SUBDIVISION REVIEW SHEET**CASE NO.:** C8J-2021-0112.1A**ZAP DATE:** April 18, 2023**SUBDIVISION NAME:** Easton Park Section 5A Final Plat**AREA:** 58.478 acres**LOT(S):** 9**OWNER/APPLICANT:** Carma Easton, LLC
and Easton QOZB, LLC (AJ Zorn)**AGENT:** Carlson, Brigance, and Doering, Inc
(Charles Brigance)**ADDRESS OF SUBDIVISION:** William Cannon and Hwy 183**GRIDS:** L12**COUNTY:** Travis**WATERSHED:** North Fork Dry Creek**JURISDICTION:** Limited Purpose**EXISTING ZONING:** Planned Unit Development (PUD)**MUD PLAN:** Pilot Knob MUD**PROPOSED LAND USE:** Multi-Family Residential, commercial, drainage/water quality, parkland and public ROW**VARIANCES:** None**SIDEWALKS:** Sidewalks will be provided along all internal streets and the boundary street.

STAFF RECOMMENDATION: Staff recommends approval of the final plat, subject to the conditions listed in the comment report dated April 13, 2023 and attached as Exhibit C.

CITY OF AUSTIN – TRAVIS COUNTY – SINGLE SUBDIVISION OFFICE
SUBDIVISION APPLICATION – MASTER COMMENT REPORT

CASE NUMBER: C8J-2021-0112.1A
REVISION #: 00
CASE MANAGER: Sue Welch
UPDATE: U0
PHONE #: 512-854-7637

SHEET NO. 2 OF 6

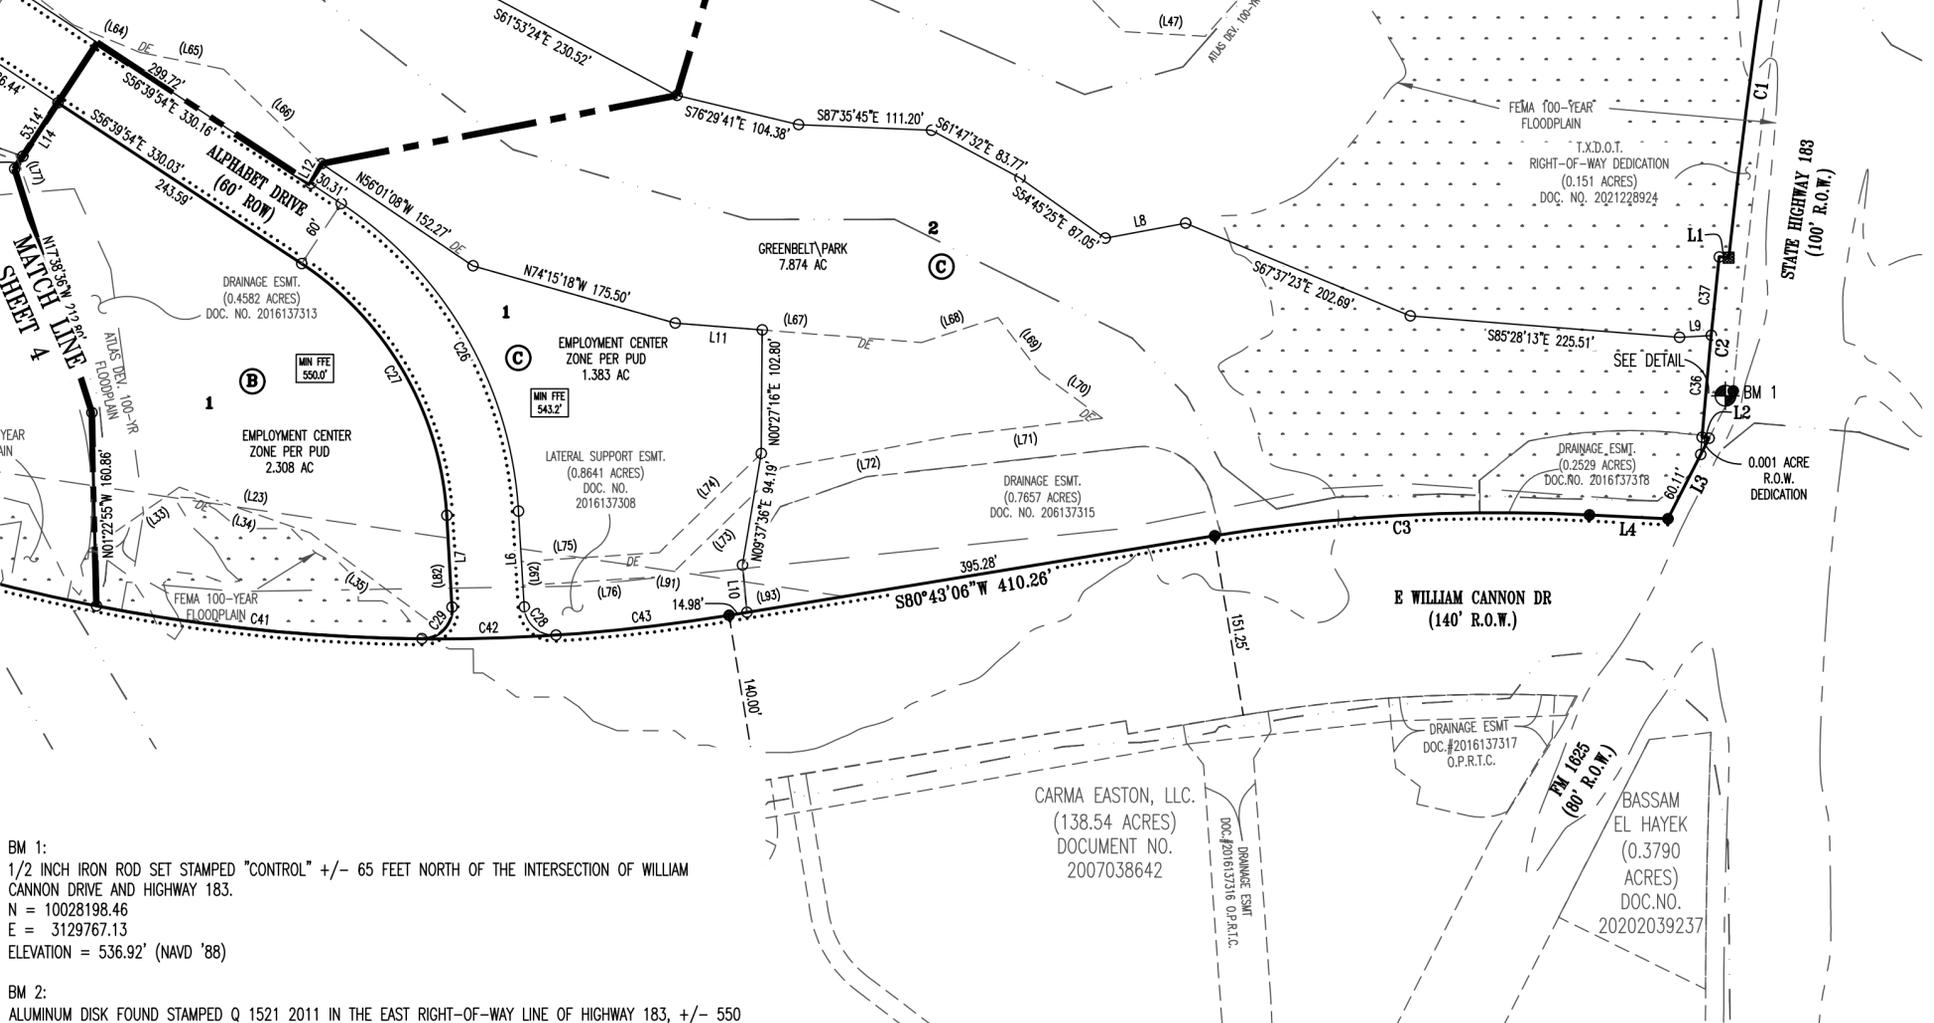
7. The preliminary plan shows the uses as multi-family and commercial – please correct page 2 of the plat to match the approved preliminary plan. 30-2-59

SHEET NO. 4 OF 6

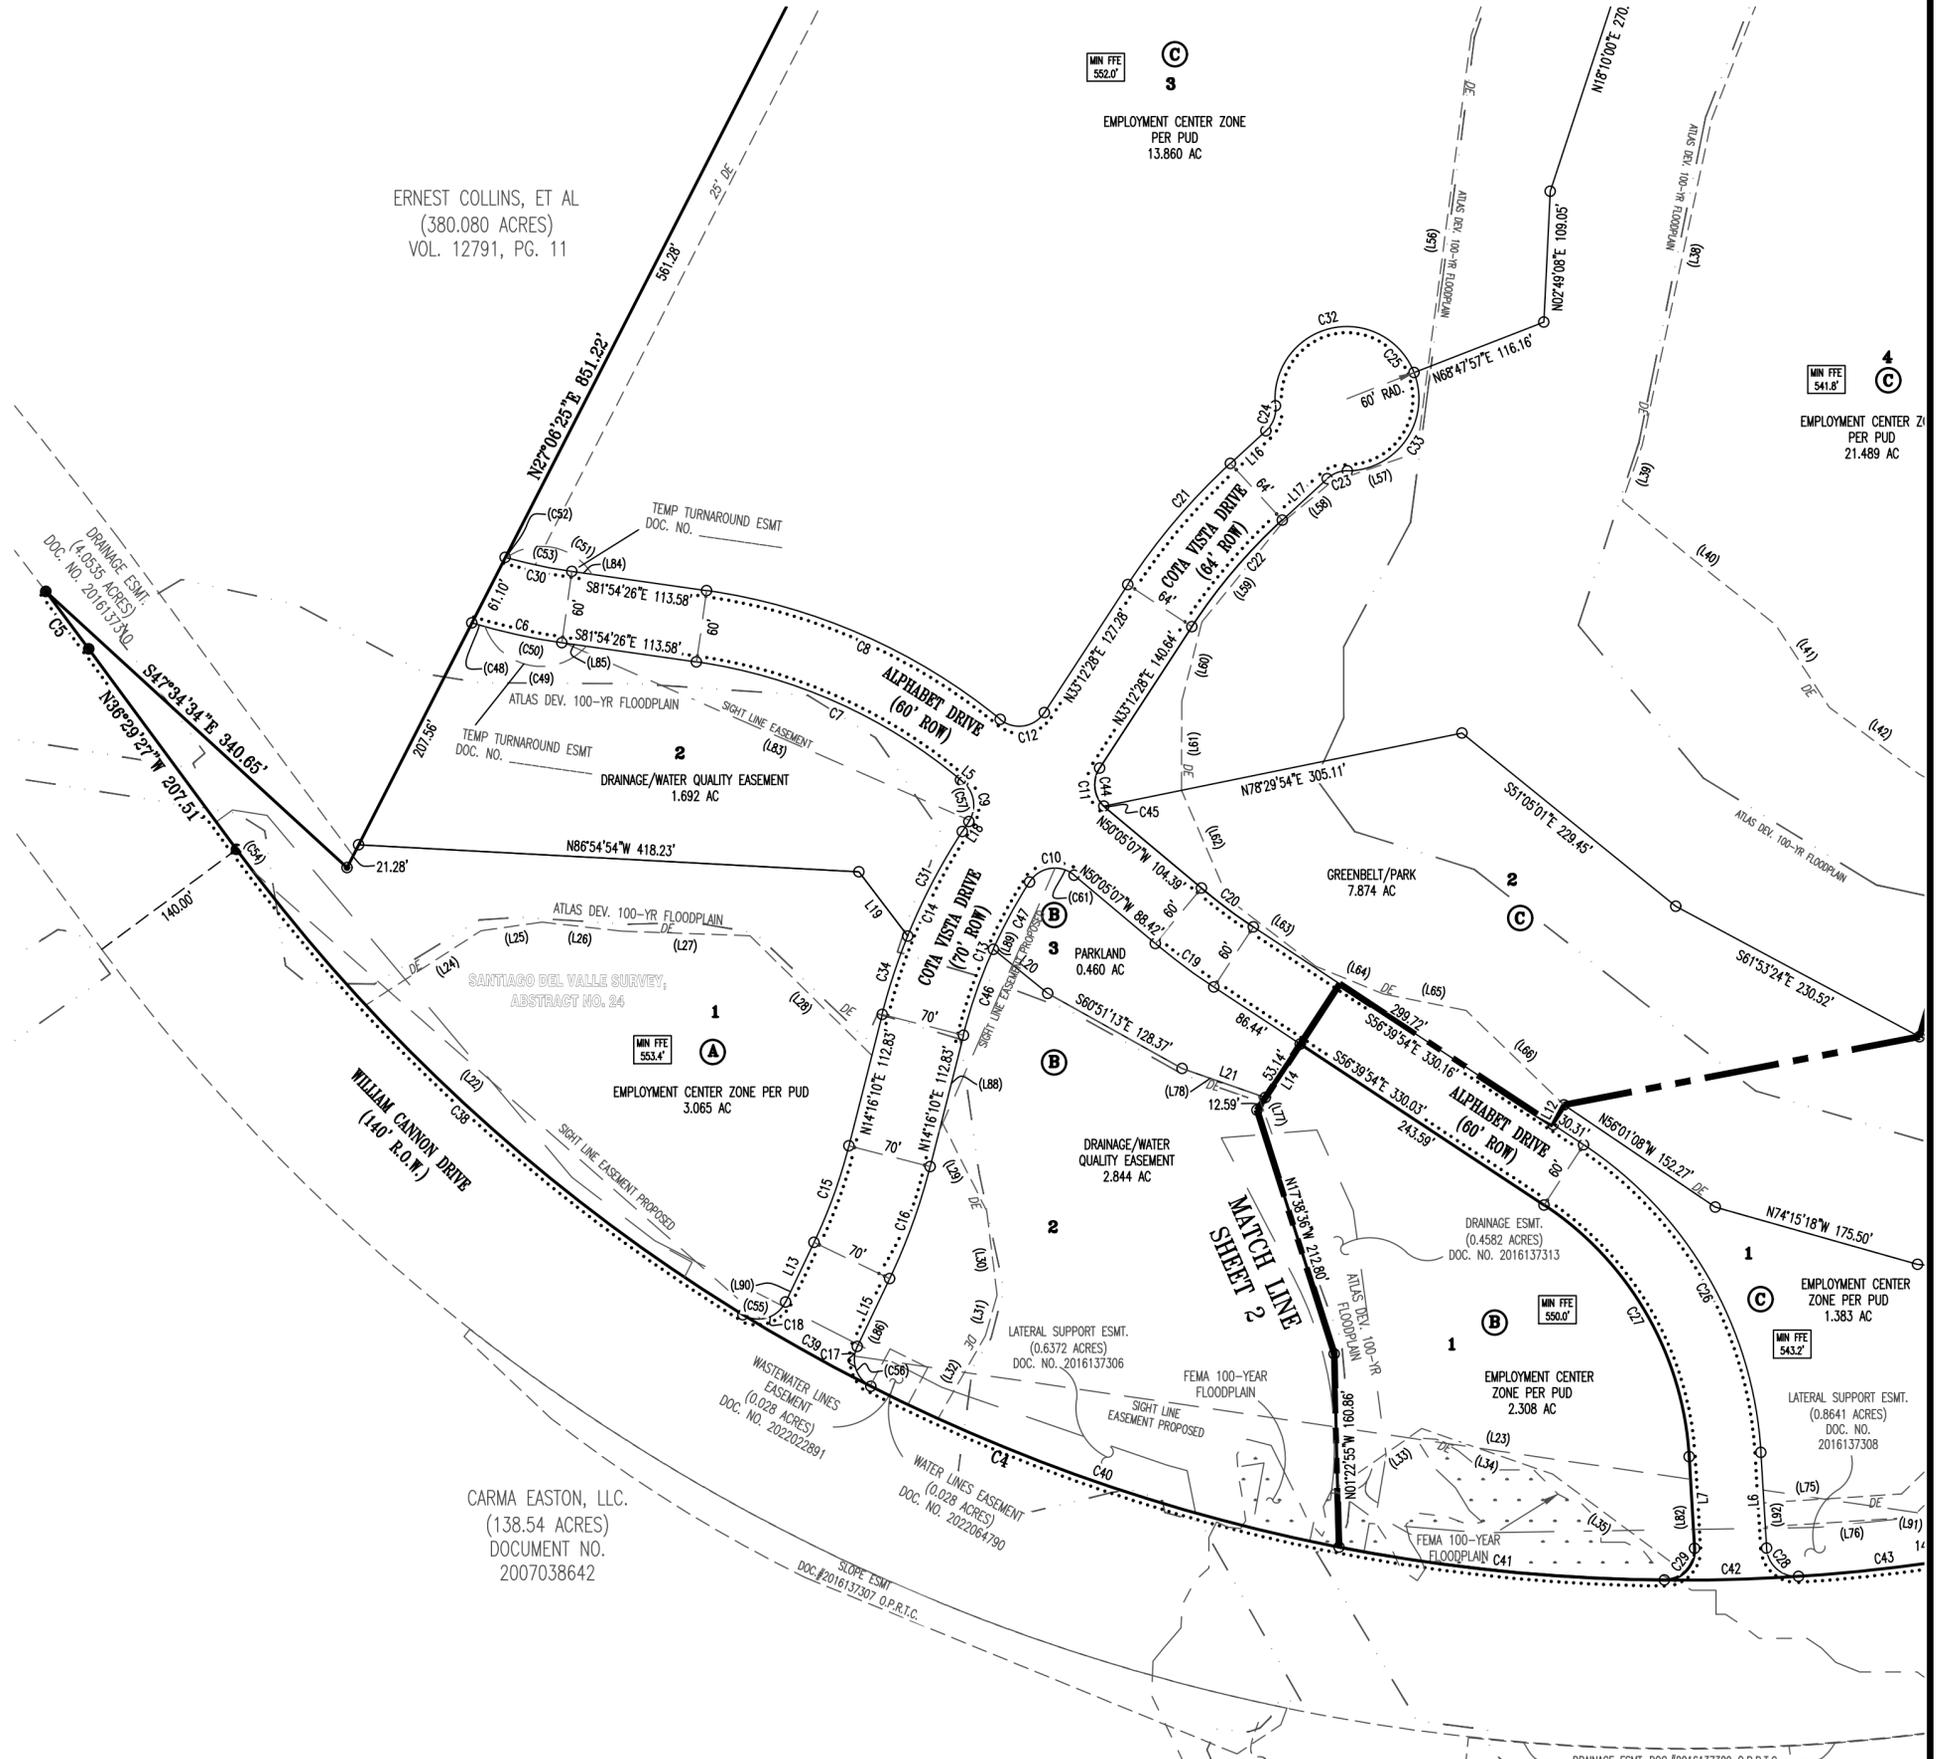
AD3: Please update label for E WILLIAM CANNON DR the directional S must be included on all sheets including sheet 4
